Planning Services Committee

Wednesday, 3 April 2013, 6.30 pm

PSC1304-46 SOUTH STREET NO.349A (LOT 2) HILTON - SINGLE STOREY GROUPED DWELLING (JS DA0039/13)

**PSC1304-47 MARINE TERRACE, NO. 88 LOT 3 FREMANTLE -
RETROSPECTIVE PLANNING APPLICATION FOR
UNAUTHORISED WORKS AND APPROVAL FOR CHANGES TO
PREVIOUS APPROVAL (SS DA624/12)**

4.6 North Elevation

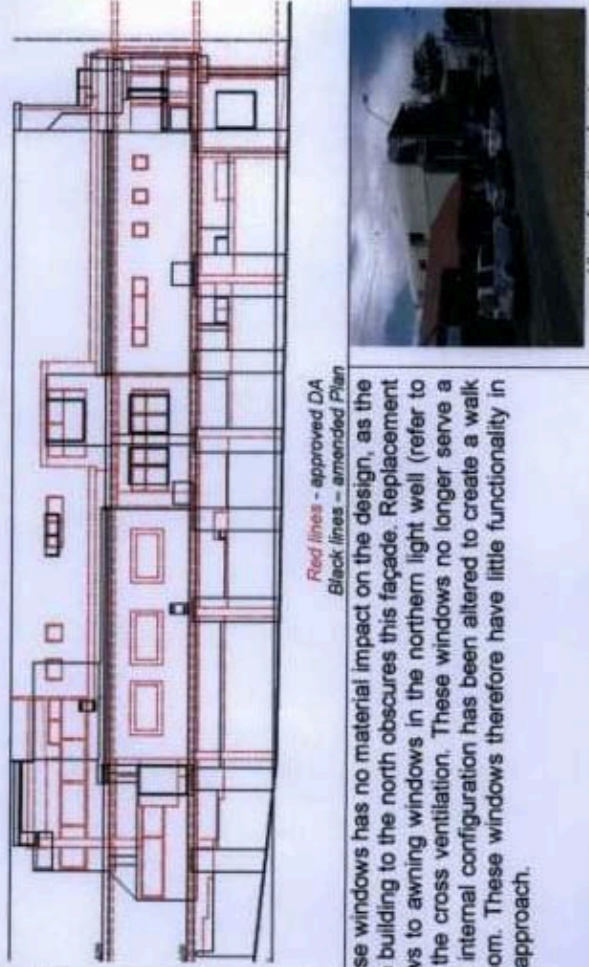
ISSUE #	CHANGE	COMMENT	ILLUSTRATION
NE1 - S	Privacy screening has been reduced to below 1.8m. Additional cladding to the building - refer to S3. Two highlight windows have been removed.	Refer to S2 on Second Floor	 <p>Red lines - approved DA Black lines - amended Plan</p> <p>View of northern facade</p>
NE2 - S	Awning windows replaced fixed obscure windows. Distance between eastern and western walls of light well reduced from 4m to 2.355m on Second Floor.	Refer to F2 on First Floor	
NE3 - F	Privacy screening has been reduced to below 1.8m.	Refer to F3 on First Floor	
NE4 - F	Windows modified from fixed obscure glazing to obscure glazing with awning window.	Refer to F2 on First Floor	
NE5 - F	Highlight windows removed	The removal of these windows has no material impact on the design, as the roof of the heritage building to the north obscures this facade. Replacement of the fixed windows to awning windows in the northern light well (refer to F2) also improves the cross ventilation. These windows no longer serve a living room, as the internal configuration has been altered to create a walk in robe and bathroom. These windows therefore have little functionality in the revised design approach.

4.7 South Elevation

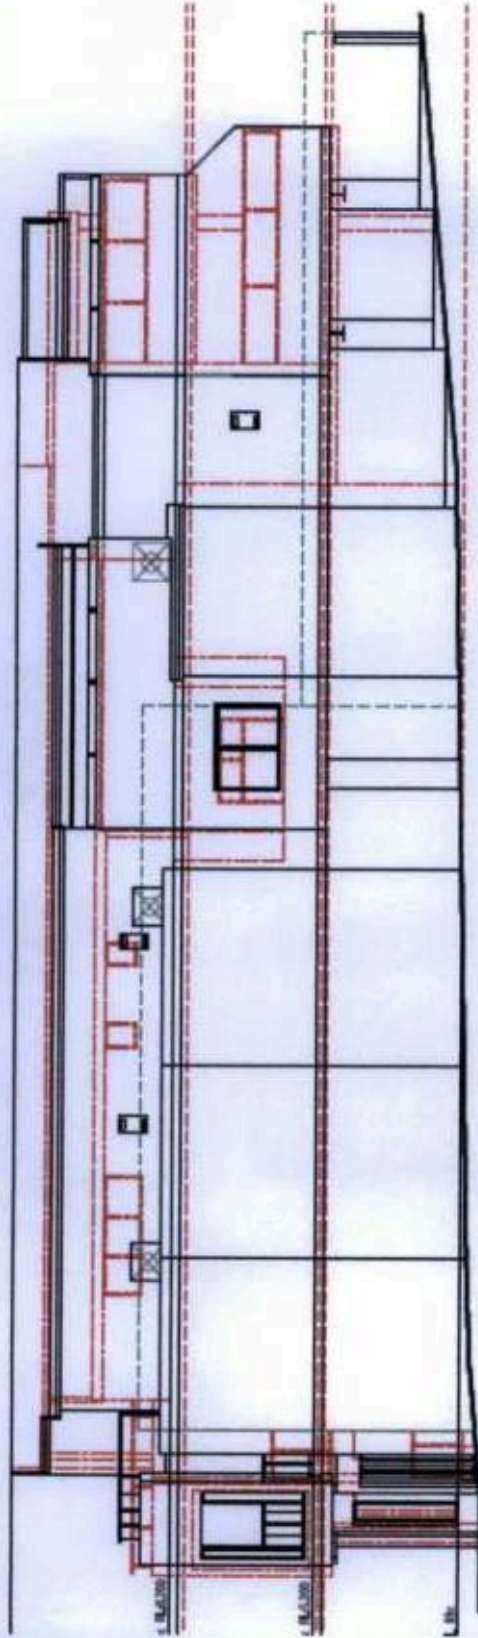
ISSUE #	CHANGE	COMMENT	ILLUSTRATION
SE1 - S	Increased length of wall by 0.5m.	The wall length of the southern sidewall of Unit 3's kitchen and lounge area increased by 410mm to 12.358m. This section of the building has an overall height of 9.75m to the roof pitch, which equates to an approximate wall height of 8.743m from ground level to the start of the 600mm bull nose roof. This wall therefore requires a setback of 1.9m under the R-Codes, for which Council previously agreed to a reduction from 1.7m to 1.22m.	 <p>View of southern facade</p>
<p>CITY OF FREMANTLE THESE PLANS FORM PART OF 14 - 12 24 DEC 2012</p>			
		<p>The residential dwelling to the south on Lot 2 is a double storey dwelling with a pitch roof - the total building height, including roof pitch, is approximately 9.115m. The existing building on Lot 2 has also been constructed up to the common property boundary and there is no private open space or windows located in this location. The kitchen section on the revised proposal plans is therefore mostly hidden from view by the existing dwelling to the south and will not overshadow or cause privacy conflicts with this dwelling.</p> <p>Issue statement WE3 - S for the Second Floor Plan reviewed the additional overshadowing of the roof form onto the Lot 2 and concluded that the additional overshadowing (7m²) is entirely on the roof space of the building. The increased wall length and reduced setback does not therefore not detrimentally impact on the amenity of the dwelling.</p> <p>The R-Codes require side setbacks to allow daylight to private open space and buildings of properties. Side setbacks also moderate the visual impact of building scale and assist with the privacy. The above statements demonstrate that the relaxation of the setback from the R-Codes would not compromise the performance standards (bulk, overshadowing, privacy and building dominance) for side setbacks, given the scale, position and nature of the dwelling on Lot 2.</p> <p>The highlight windows have limited functionality for the kitchen areas and cross ventilation will be achieved from the balcony to the southern light well. This facade is also mostly hidden from street view by the existing building on Lot 2. The removal of these windows has no material impact on the design outcome. Refer to S4 for the Second Floor.</p>

SE2 - S	Highlight windows deleted		
SE3 - S	Privacy screening has been reduced to below 1.8m.		
SE4 - F	Windows modified from fixed glazing to obscure glazing with awning window.	The view from these windows is onto the blank wall and roof of the double storey dwelling to the immediate south. There is therefore no overlooking or privacy concerns about the change in windows. Notwithstanding this, the amended plans specify a limitation of 50mm to the opening of these awning windows and there should therefore be no visibility from these windows beyond the windowsills.

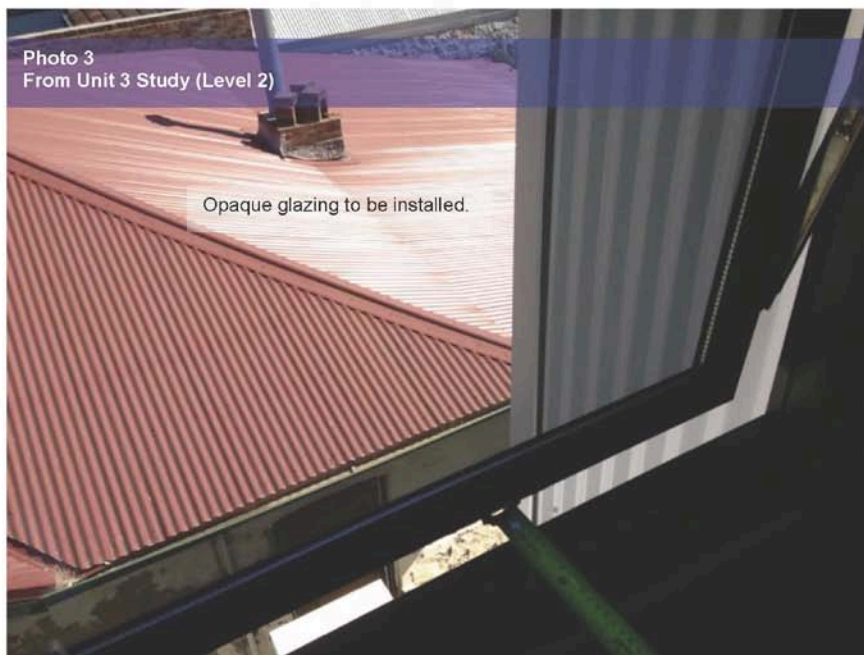
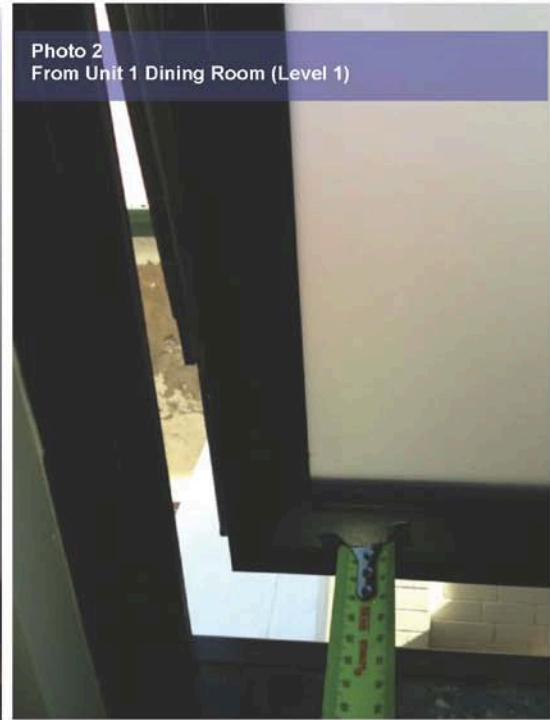
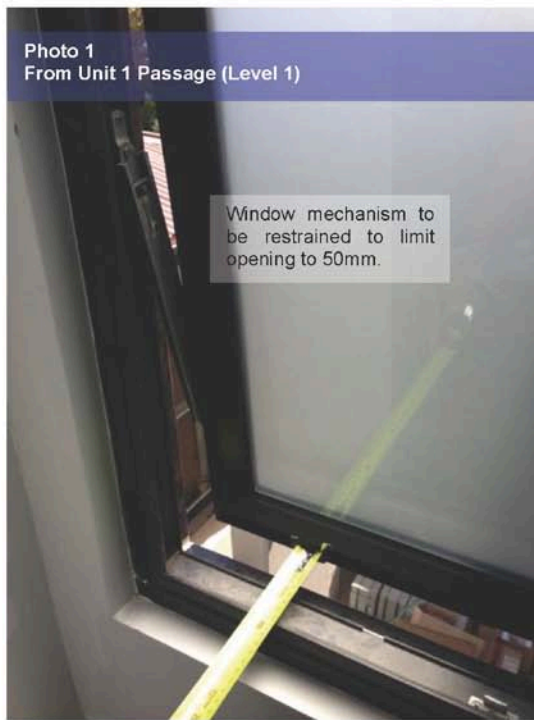
While there is a specified limitation of 50mm opening of these awning windows, there is still visual access from these windows beyond the window sills, despite the strategic angle of the photograph to suggest otherwise. Our concerns relate to the use of awning windows instead of fixed opaque windows as agreed in the original Development Approved (DA) plans. In the longer term the neighbours on the northern and southern sides are no longer able to be confident of privacy in their homes and yards. The recessing of the windows may reduce visual access slightly, but the ability to open these awning windows means some physical and emotional privacy is lost. This is why the fixed, opaque windows were agreed to in the original DA.

Our concerns relate to the low balcony wall height for Unit 1 which is at present less than 1.65m high and is not yet 1.80m as stated at 4.2: F3/page 5 in the plans. This balcony affects the privacy of the rear yard of 86 Marine Terrace and our home at 4 Russell Street.

Unit 3's upper balcony is 1.65m high and this is less than 1.8m agreed upon and has visual access to our yard. Currently, it requires the installation of the powder-coated aluminium screen to bring it up to 1.8m. It is unacceptable to us to reduce the height of the Unit 3 upper balcony wall for 'distant views' which will, of course, include our property. The plans for the upper balcony indicate this will be an entertainment area, and lower external walls will impact our privacy and amenity. Installation of the powder-coated screens have not occurred yet, and will be required to bring the height to its required 1.80m to address these concerns.

The planning report in support of the Retrospective Planning Application states that the awning windows will be restrained to a maximum opening of 50mm and opaque glazing will be affixed. These works have not yet been executed.

The photographs in one of the submissions show the outlook from these windows without these view restrictions in place, whereas the photographs attached hereto demonstrate the impact of restricting the opening to 50mm and for an opaque window.

The report in support of the Retrospective DA plans argued for a combination of solid and permeable screening of the balconies up to a height of 1.8m to comply with the current DA conditions. These works are yet to be implemented. For all of the balconies in question, the balcony balustrade will be a solid wall

Insofar as Unit 3 is concerned, S4 in the planning report states that the rear balcony balustrade will be constructed as a solid wall up to 1.65m with horizontal louvers being applied to the remaining 150mm up to a height of 1.8m. The balcony balustrade will not be lowered to 1.65m, as suggested in one of the submissions. The use of horizontal louvers will impede on overlooking to the properties to the east, but will allow distant views. In doing so, the approach constitutes a minimum 91% solid balustrade at the required 1.8m height to exceed this requirement under the DA conditions.

Photograph 3 – taken in passageway looking towards 86 Marine terrace – refer to Item No. F2 of report

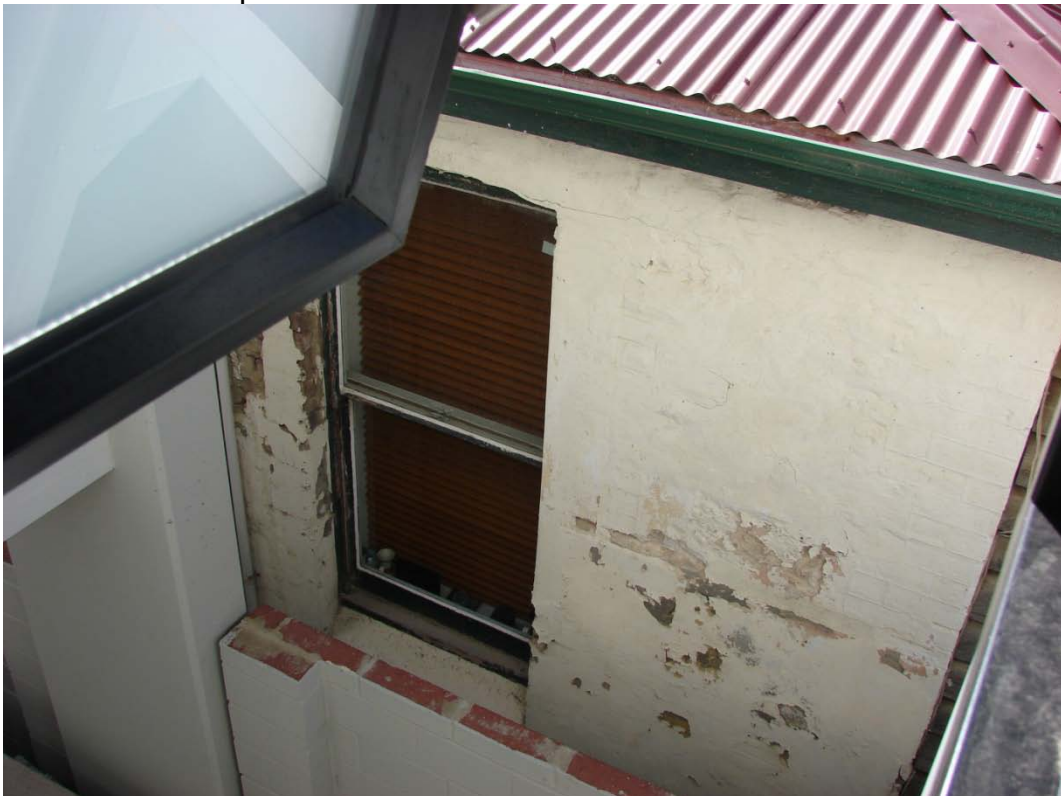
Photograph 1 – unauthorised service area to Marine Terrace – Refer to Item No. G1 of report.

Photograph 2 – passageway at first floor level – northern side – refer to Item No. F2

Photograph 5 – screening erected to rear balcony of unit 1 – refer to Item No F3

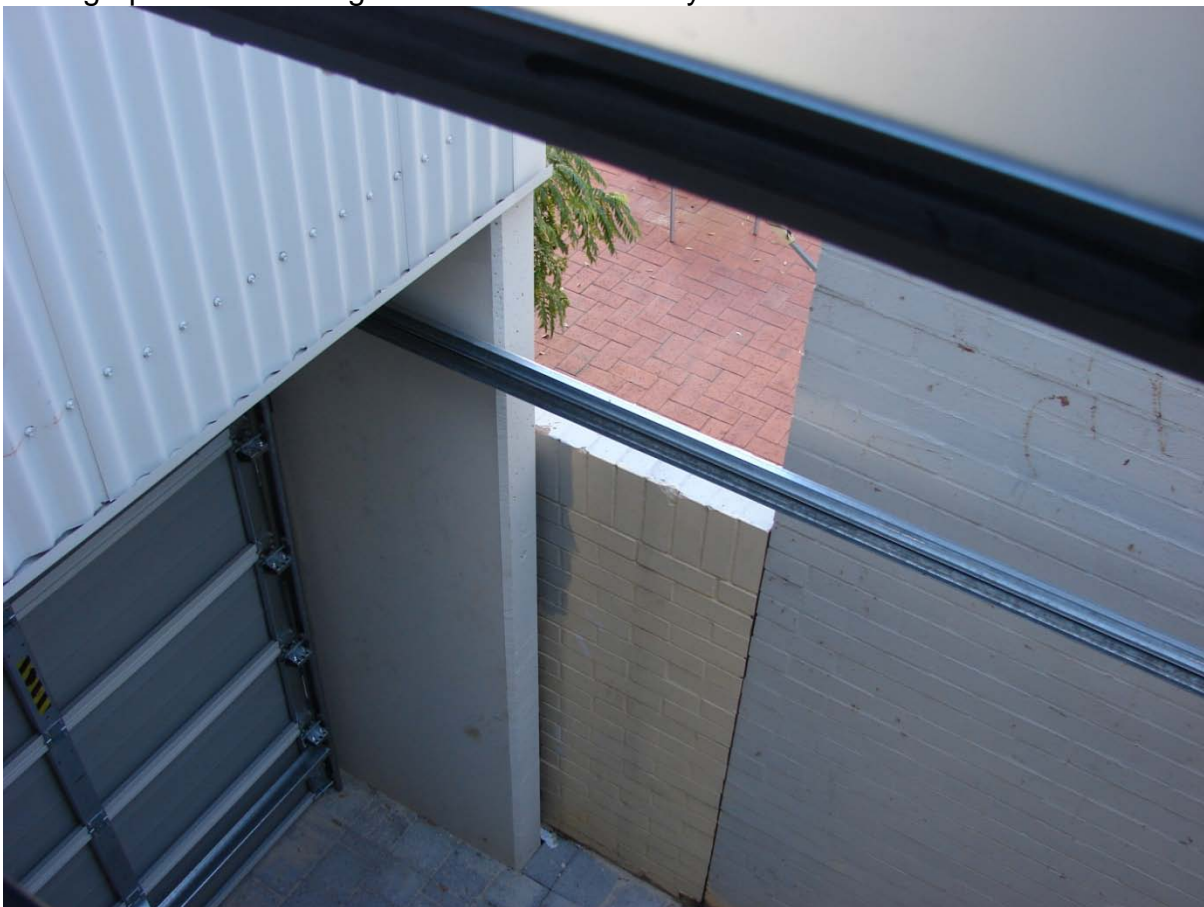
Photograph 6 – southern view from bedroom 4 - refer to Item No F7
